**WOODLAND NOTCH
CONDOMINIUMS**

BURLINGTON,
CONNECTICUT

Environmental Review Team Report

APRIL 1990

Figure 7

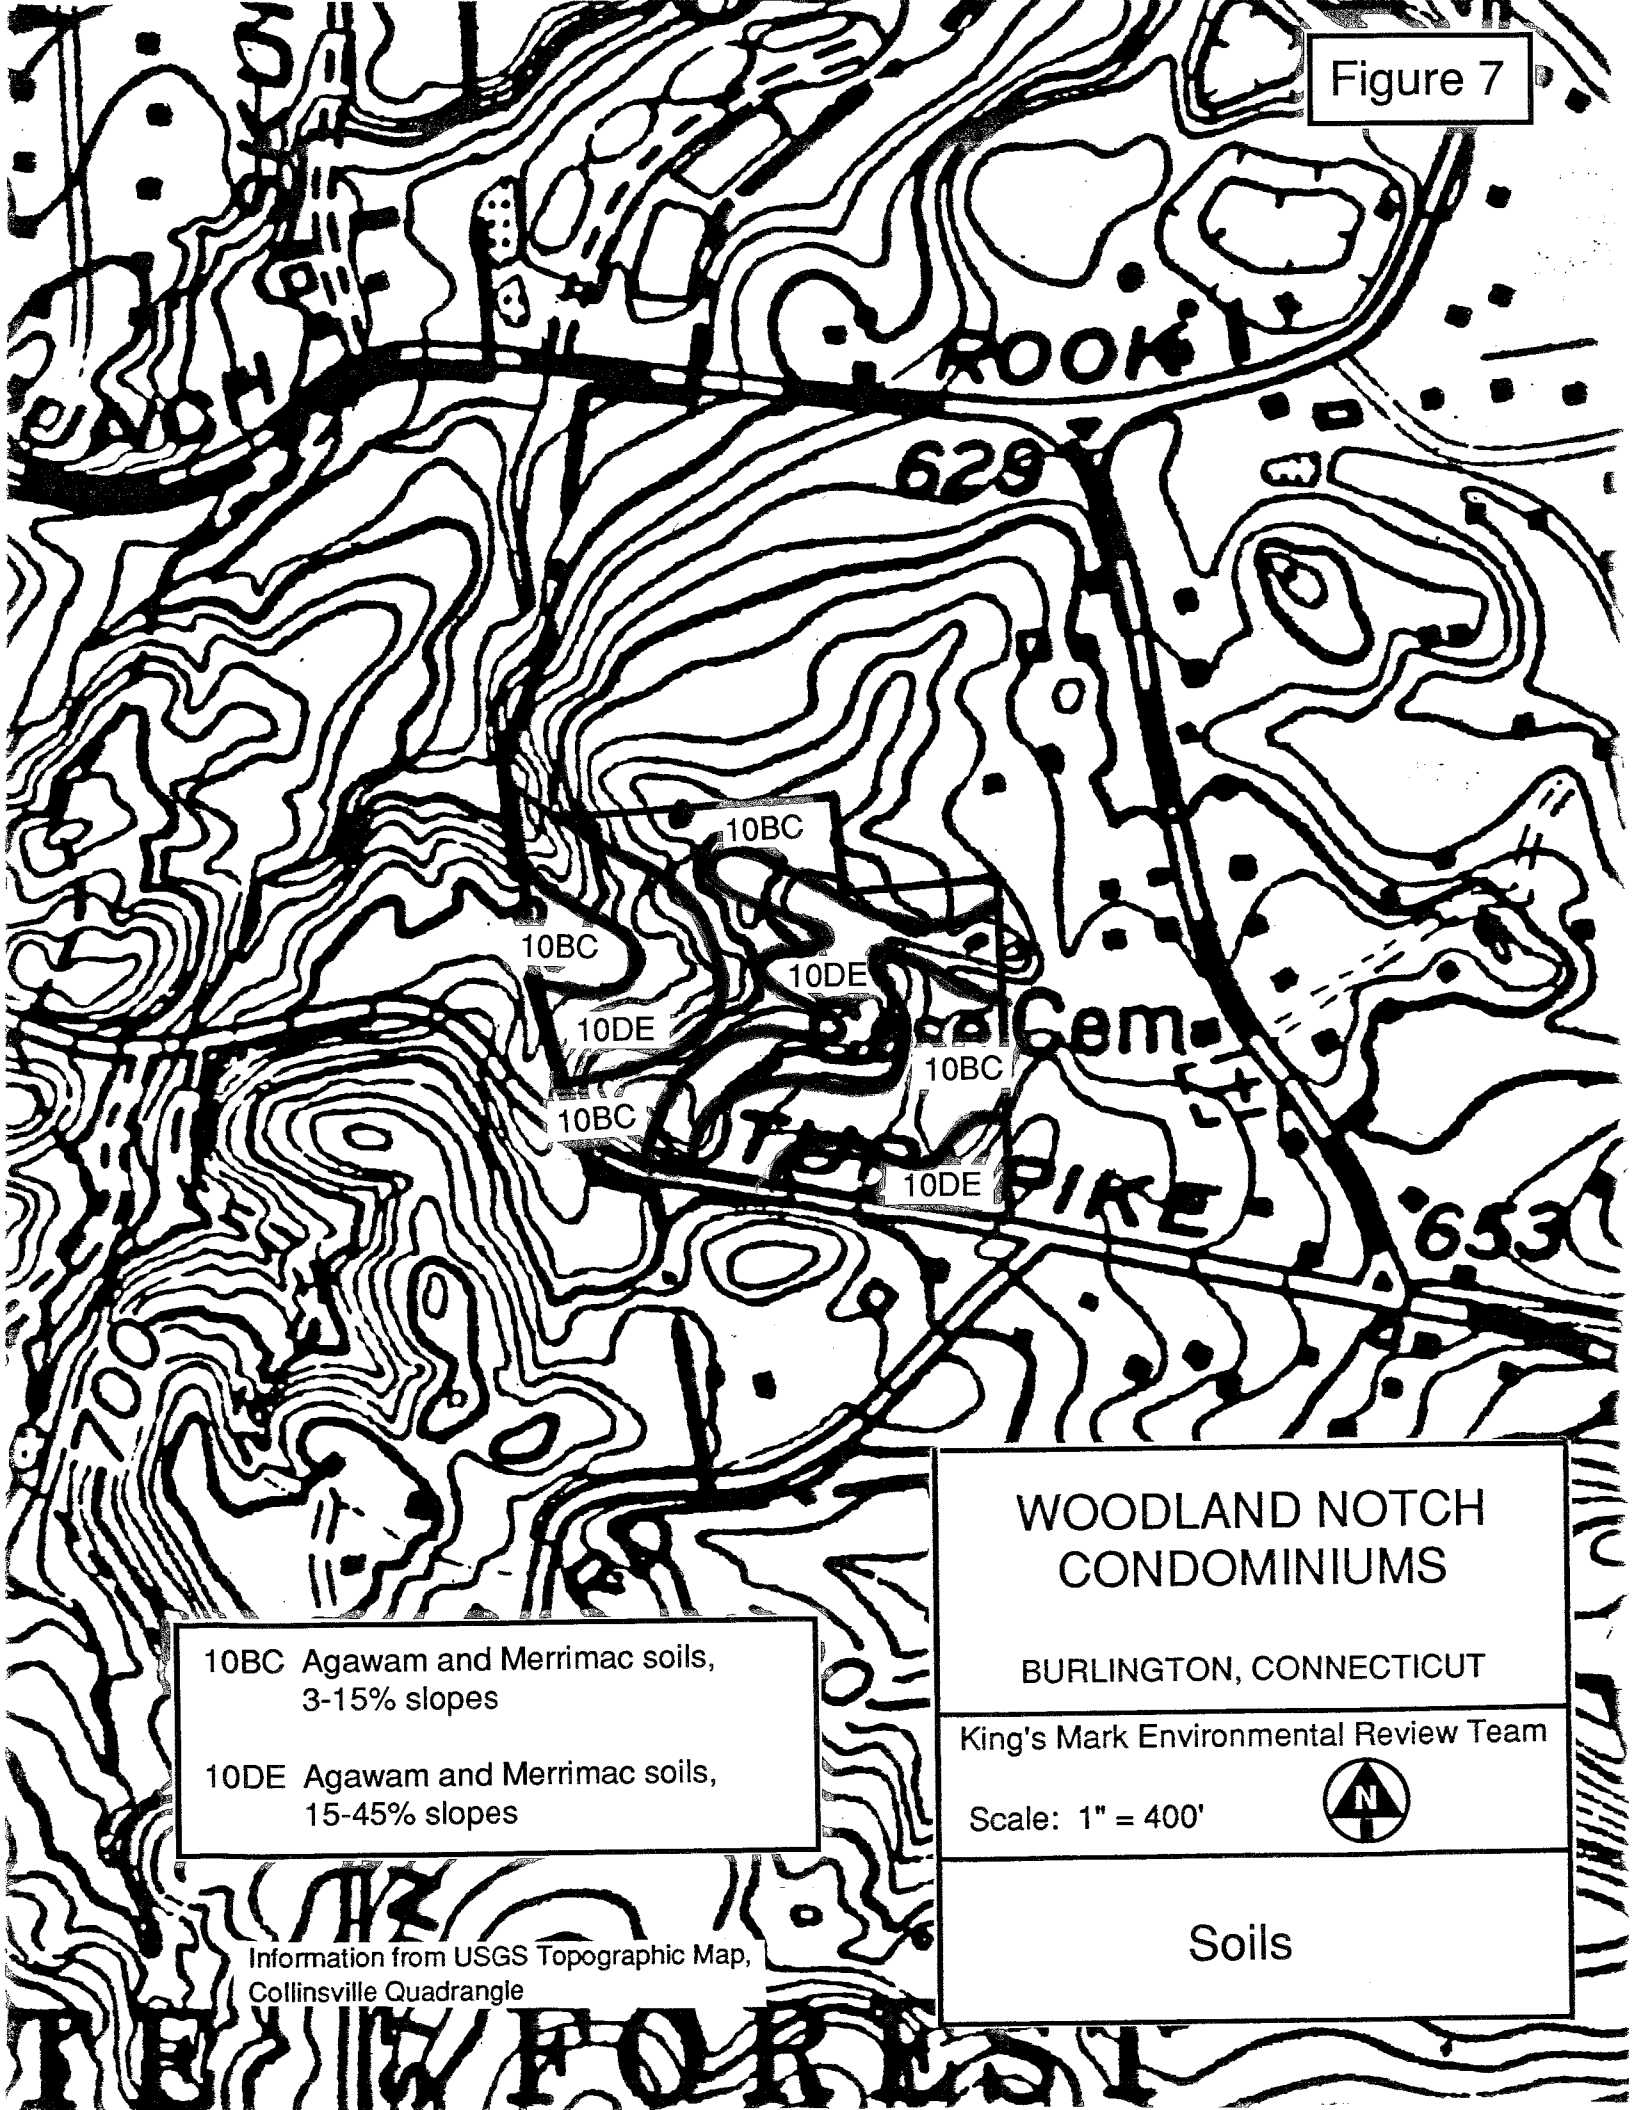
The soil map (Figure 6) has been created from on-site investigation during the field review and air photo interpretation. Therefore, the map and map unit descriptions have been modified from the Hartford County Soil Survey, 1962 to more accurately reflect site conditions and current concepts. Soil interpretations have been included in the map unit descriptions.
